**Trinity River Channel Rehabilitation Sites:**

**Douglas City (River Mile 93.6-94.6) and Lorenz Gulch (River Mile 89.4-90.2)**

**Final Environmental Assessment/Initial Study**

**Part 3: Appendix A: Mitigation Monitoring and Reporting Program and Appendix B: Response to Comments (page 215-262)**

**Figure 1. Areas of existing coarse sediment deposition.**

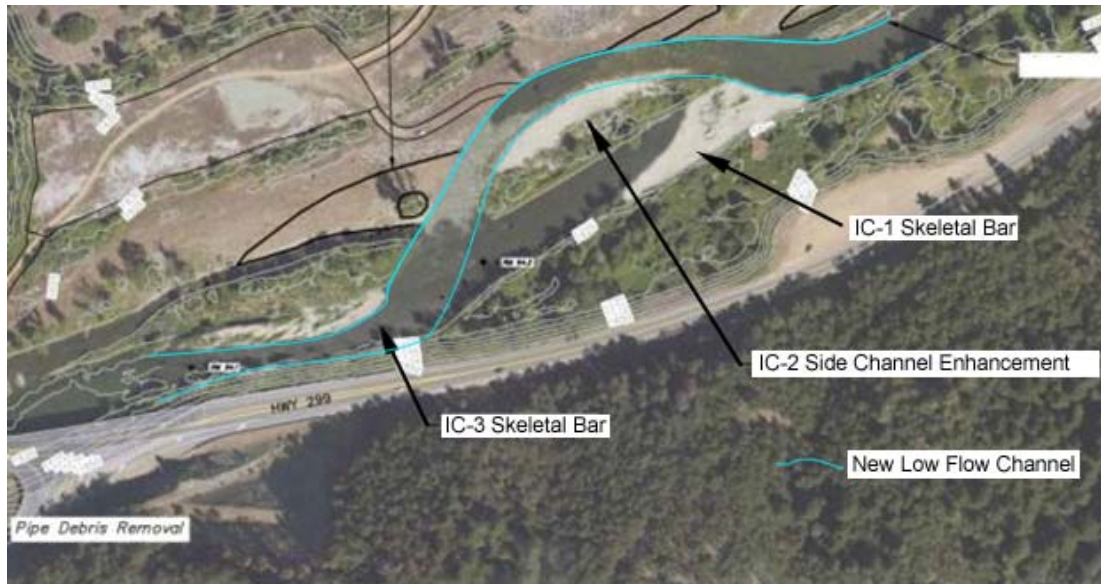
**DCY Comment #1:** The TRGA is concerned that the Forced Meander at this site (IC-1, IC-2, and IC-3) will reduce adult salmonid holding and spawning habitat as well as habitat for juvenile

**Response:** The construction of a right bank side channel upstream of the HWY 299 Bridge (Douglas City Bridge) at Douglas City (River Mile 94) in 2007 increased overall channel width. Construction activities in 2007, in combination with a large coarse sediment supply from Indian Creek and Weaver Creek delta backwater effects, have increased deposition of coarse sediment within the mainstem channel. Although coarse sediment deposition is desired, as it leads to a more complex channel and improved salmonid habitat for all life stages, the channel response time is slow (Figure 1). Project Areas IC-1, IC-2, and IC-3 are intended to move the channel evolution process forward in a more rapid manner by: 1) augmenting the existing coarse sediment deposits (IC-1 and IC-3); and 2) widening the existing side channel (IC-2) to a mainstem geometry that is scaled appropriately to the Trinity River Record of Decision high flow regime (Figure 2). The proposed design provides channel geometry and sinuosity that is expected to: 1) promote bed and bank scour within Project Area IC-2; and 2) improve mainstem hydraulics that increase bed scour and sediment transport along the left bank, enhancing the existing steelhead run adjacent to Project Area IC-3, just upstream of HWY 299. The scaling of the Trinity River to the Record of Decision high flow regime is fundamental in restoring the ecological processes that maintain salmonid habitat for all life stages.
